RE: SES Solar One Project
Applicant's Responses to the CEC Memo Regarding Transmission Line Upgrades

SES Solar One
Response to CEC Memorandum
Docketed 12/8/2009
08-AFC-13

TECHNICAL AREA: TRANSMISSION LINE UPGRADES

SOIL, FLOODPLAIN AND GEOHAZARDS
SOLAR 1
SCE TRANSMISSION LINE UPGRADES

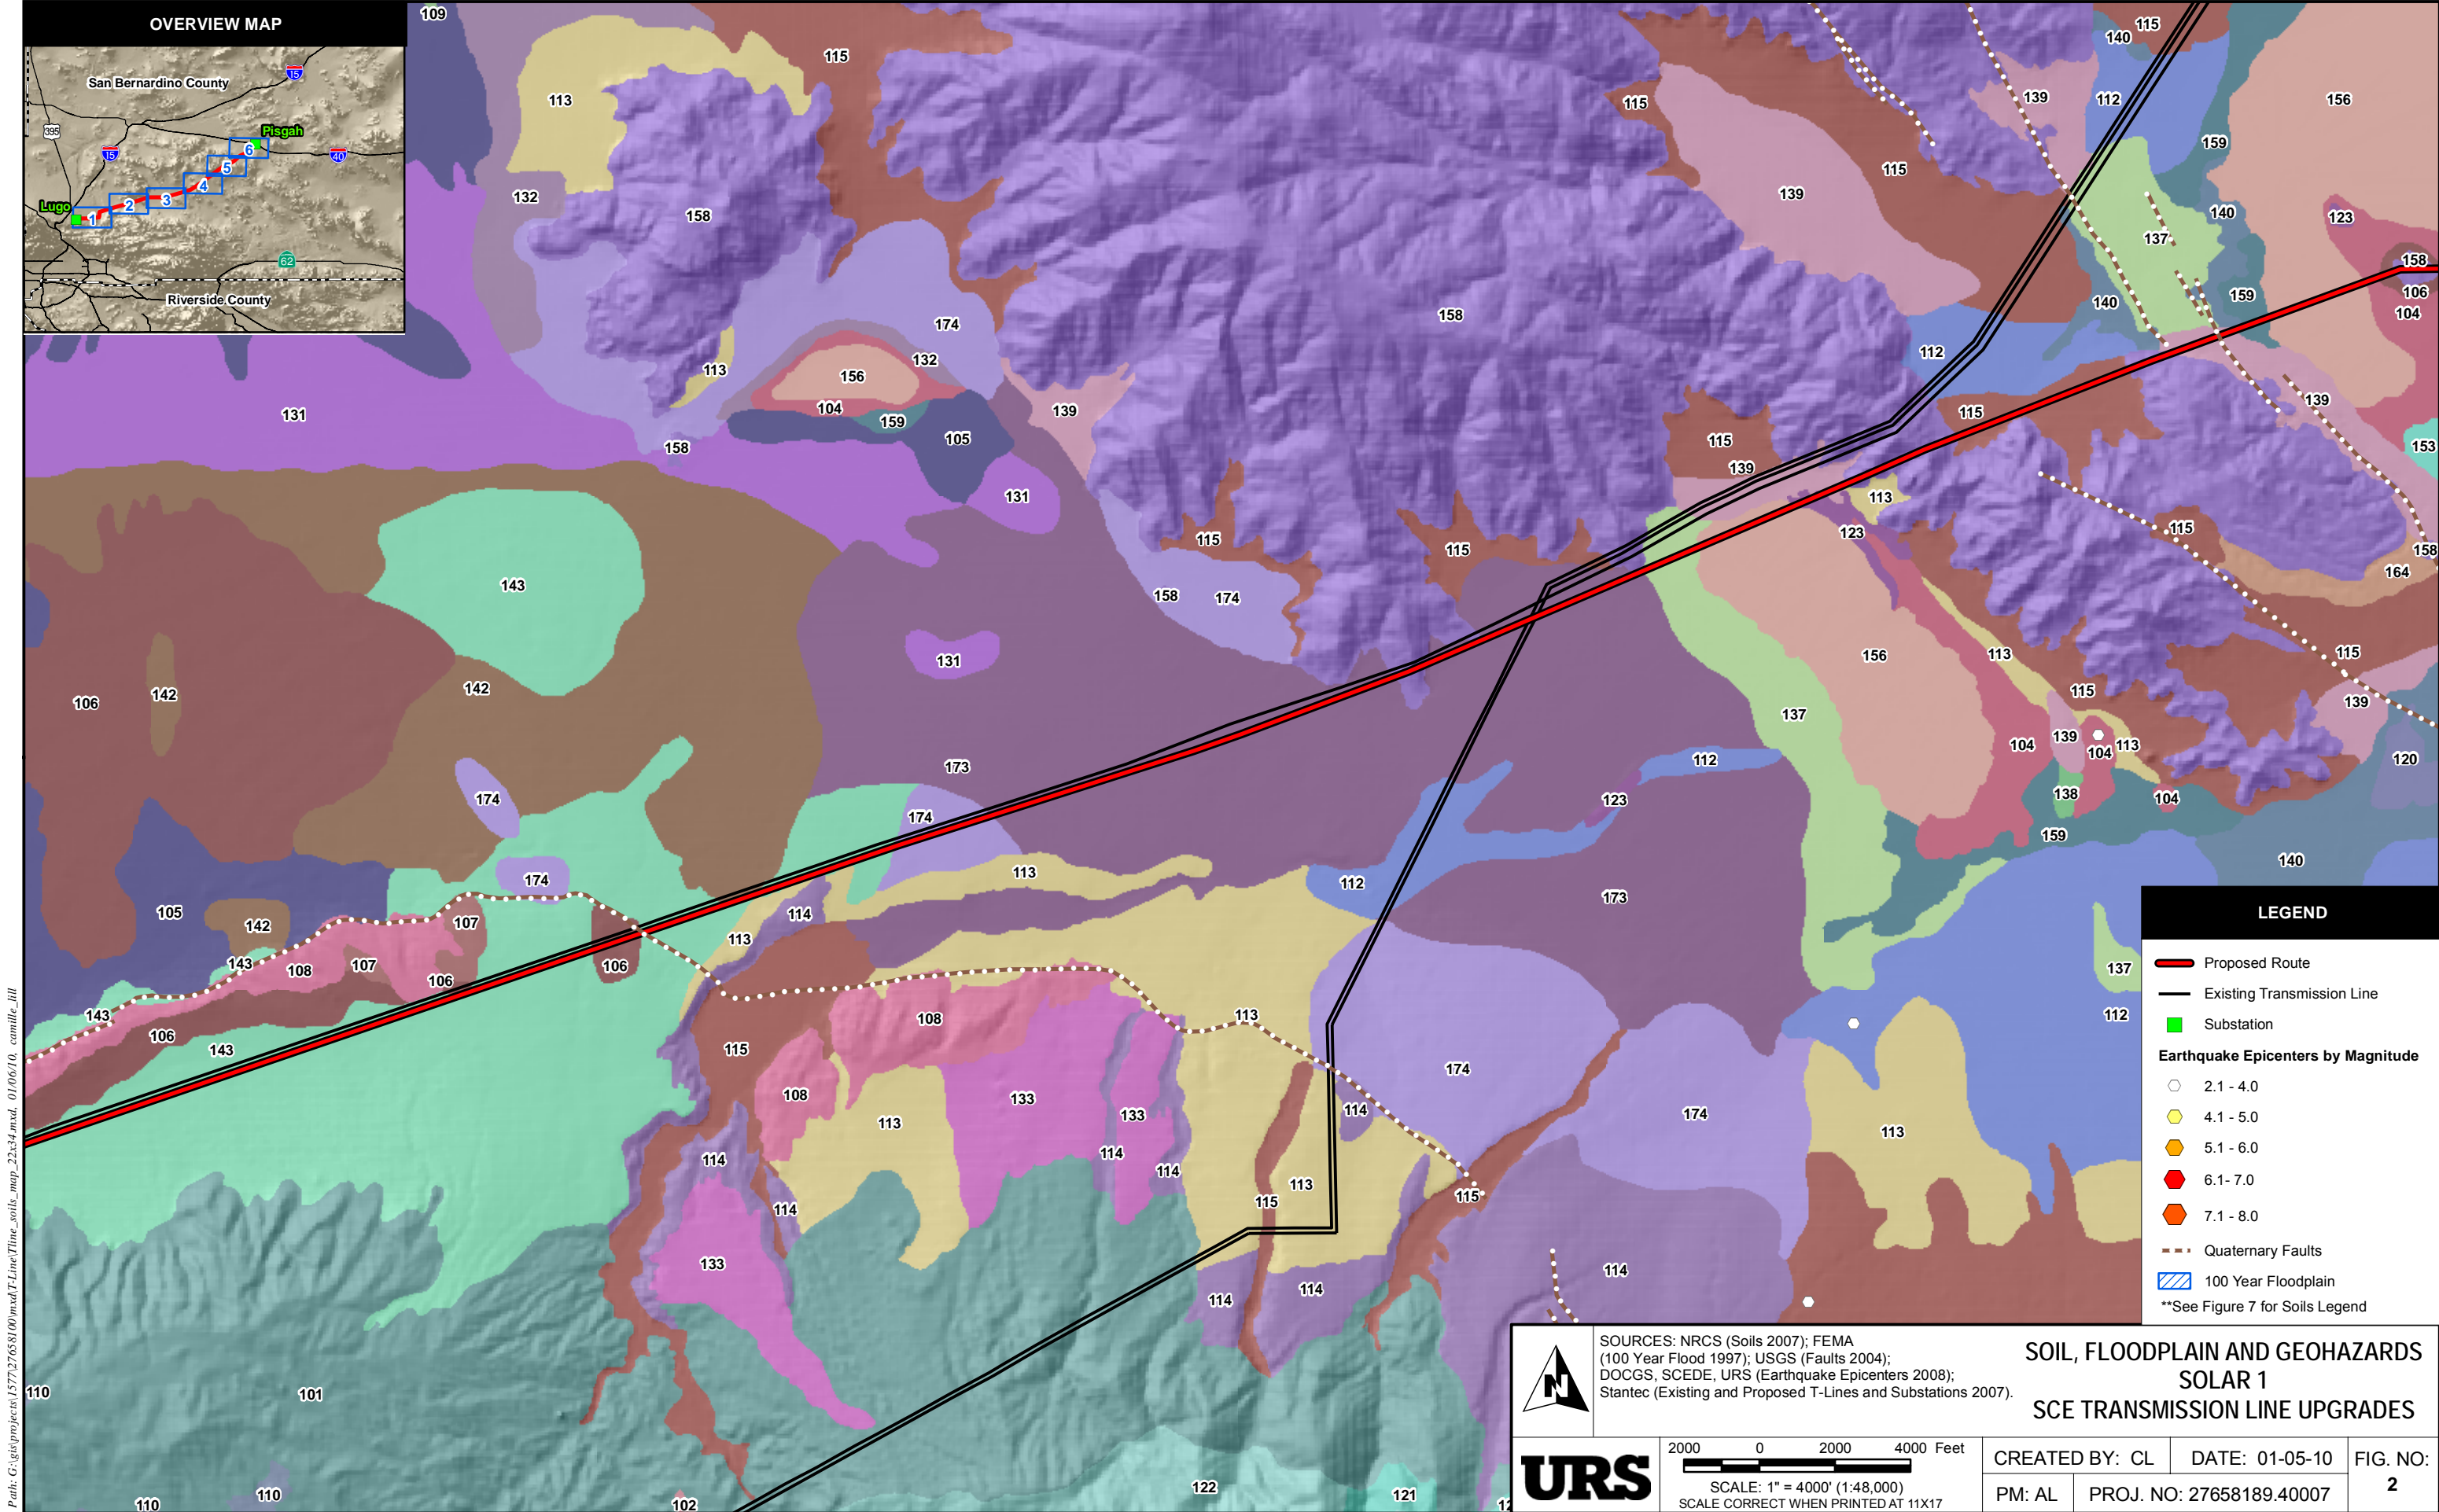
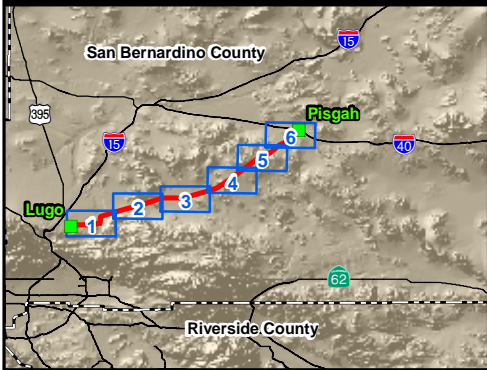
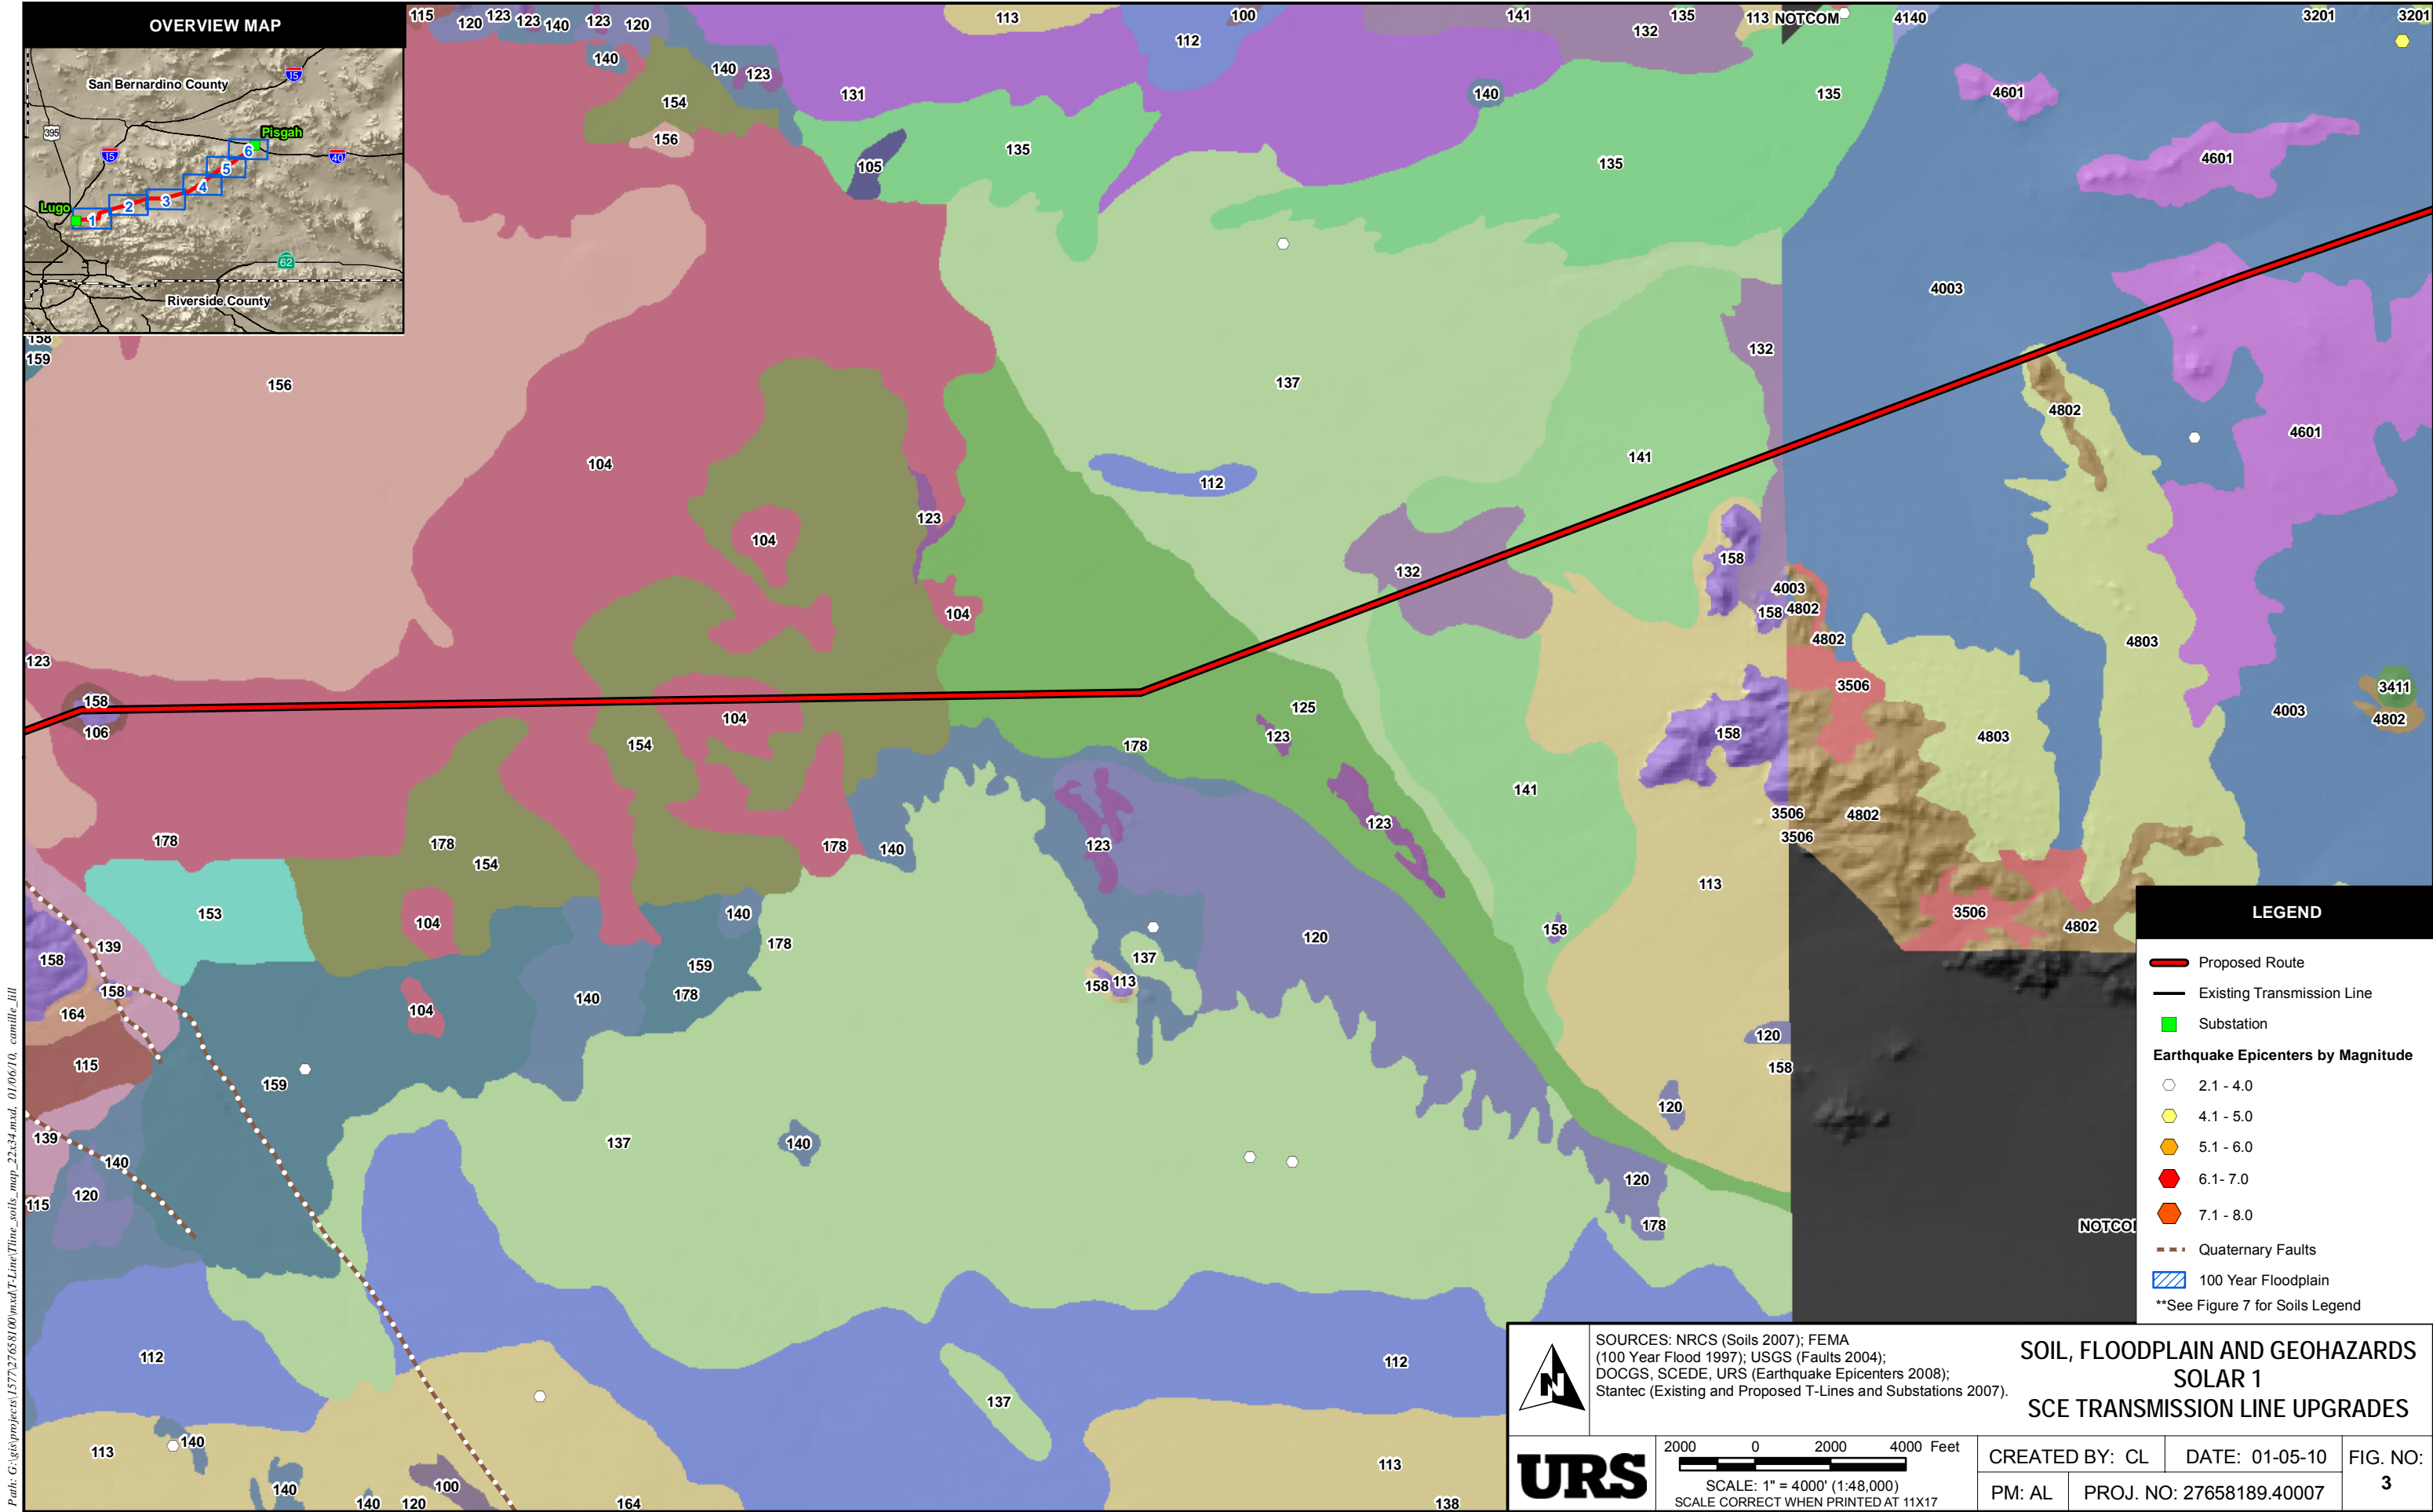
Item 8: Identify locations where the alignment of transmission line upgrades cross 100-year flood zones.

Response: The location of the transmission line alignment in relation to FEMA's Flood Insurance Rate Map Zones, including Zone A (the 100-year flood zone), is provided in attachment TRANS-4, located behind this response.
